HISTORIC AND DESIGN REVIEW COMMISSION

June 19, 2019

HDRC CASE NO: 2019-316
ADDRESS: 626 AVENUE E
LEGAL DESCRIPTION: NCB 443 BLK 5 LOT 1
ZONING: FBZ T4-2, HS
CITY COUNCIL DIST.: 1
LANDMARK: Schiebel / Richardson House #1
APPLICANT: Thomas Tamez
OWNER: Rey Feo Scholarship Foundation & LULAC Council #2
TYPE OF WORK: Front Yard Fence
APPLICATION RECEIVED: May 28, 2019
60-DAY REVIEW: July 27, 2019
CASE MANAGER: Huy Pham
REQUEST:

The applicant is requesting a Certificate of Appropriateness for approval to install a five-foot (5') tall wrought iron fence in the front yard.

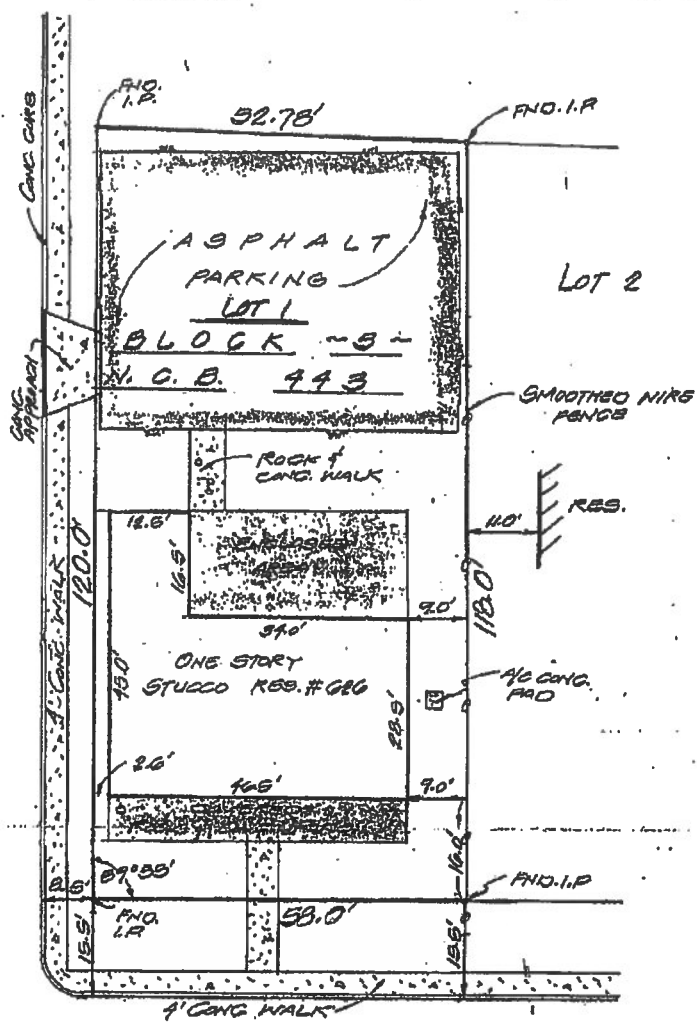
- b. FENCE – The applicant is proposing to install a 5 foot (5') tall wrought iron fence in the front yard.
- c. LOCATION – Per the Guidelines for Site Elements 5.2.B.ii., front yard fences should not be introduced in a location that did not historically have them. Staff finds that front yard fences are typical to structures of this architecture style and context.

- d. HEIGHT – Per the Guidelines for Site Elements 5.2.B.iii., front yard fences should be limited to a maximum of four feet (4') in height. Staff finds that the proposed height of five feet (5') is inconsistent with the Guidelines and should be reduced.
- e. DESIGN – The Guidelines for Site Elements 5.2.B.i., the design of the fence should respond to the design and materials of the house or main structure. Staff finds that the proposed wrought iron fence is appropriate to the style of the structure.
- f. COMPLIANCE – A signage request for 626 Avenue E was heard at the HDRC hearing on December 5, 2018, and was denied. The sign was installed prior to approval and has not been removed. Compliance should be met prior the issuance of a Certificate of Appropriateness for fencing.

- i. The height of the fence should be reduced to a maximum of four feet (4') in height.
- ii. Unapproved signage must be removed prior to the issuance of a Certificate of Appropriateness for fencing.
